UNITED STATES PATENT AND TRADEMARK OFFICE

APPLICATION NO.	FILING DATE	FIRST NAMED INVENTOR	ATTORNEY DOCKET NO.	CONFIRMATION NO.
10/082,808	02/22/2002	Doron Kreiser	BEL1030U	2056
25197	7590	06/16/2004	EXAMINER	
LEARY & ASSOCIATES 3900 NEWPARK MALL RD. THIRD FLOOR, SUITE 317 NEWARK, CA 94560			NATNITHITHADHA, NAVIN	
			ART UNIT	PAPER NUMBER
			3736

Office Action Summary

DETAILED ACTION

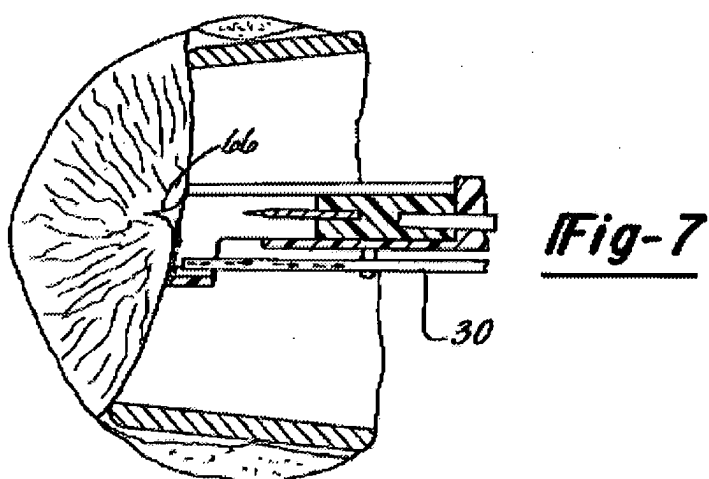
Claims 1 and 2: Sarrine discloses a device 10 for measuring fetal blood pH (see col. 1, lines 10-27), comprising: a lancet 40 extendable from a distal end of the device for incising tissue (see fig. 4 below); and a capillary 30 at the distal end of the device for collecting a sample of blood for pH analysis (see fig. 1 and 7 below).

Sarrine discloses the capillary 30 is in a fixed position (see col. 2, lines 59-62) and not extendable from the distal end of the device 10. After the incision of the tissue, blood flows downward and into the fixed capillary tube (see fig. 7 below).

**Fig. 64**

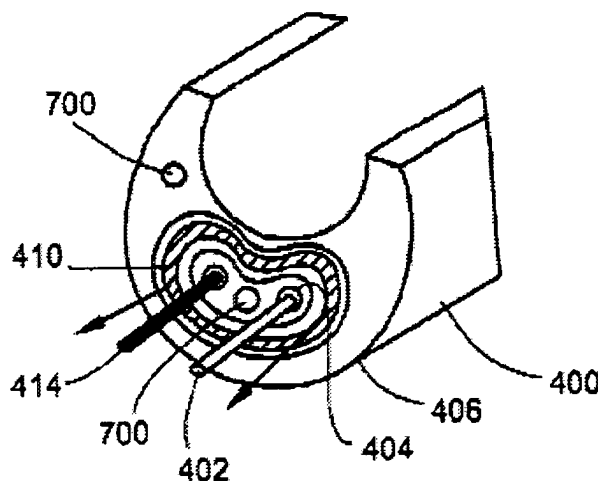
However, Levy et al discloses a device comprising: a lancet 414 extendable (ejectable) from a distal end of the device for incising tissue (see fig. 64 below and col. 21, lines 46-55); and a capillary 402 extendable (ejectable) from the distal end of the device for collecting a sample of blood (see col. 21, lines 25-35). It would have been obvious for one of ordinary skill in the art at the time the invention was made to modify Sarrine's device to have both a lancet and a capillary extendable from the distal end of the device in order to effectively sample blood from any position of the device.

Claims 5 and 7: Levy et al discloses a lancet (puncturing device) 414 and capillary 402 are slidably (ejectably) mounted in a guide tube (sleeve) 410 (see fig. 64 above).

The guide tube 410 is shown in figure 64 as being one body having two tubes, in which both tubes can be considered a lancet guide tube and a capillary guide tube.

Fig. 1

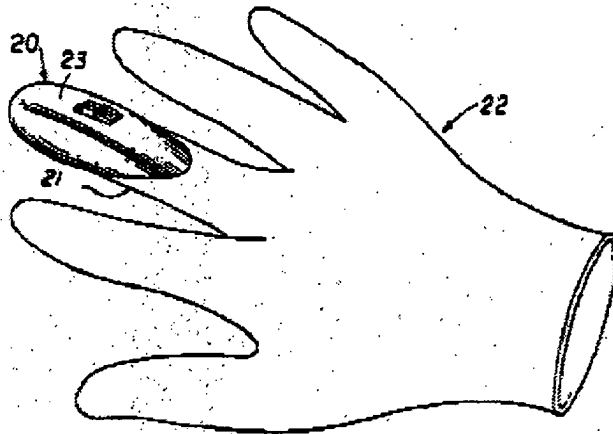
Sarrine discloses a handle type member 14 and not a means for mounting the device to an operator's hand in the form of a surgical glove. However, Salterwhite discloses a device comprising: a means 22 for mounting the device to an operator's hand in the form of a surgical glove 22 (see figs. 1 and 5); and a lancet 42 extendable from a distal end of the device for incising tissue. It would have been obvious for one of ordinary skill in the art at the time the invention was made to modify Sarrine's device to be mounted

on an operator's hand in the form of a surgical glove in order to more easily place a lancet at an incision site.
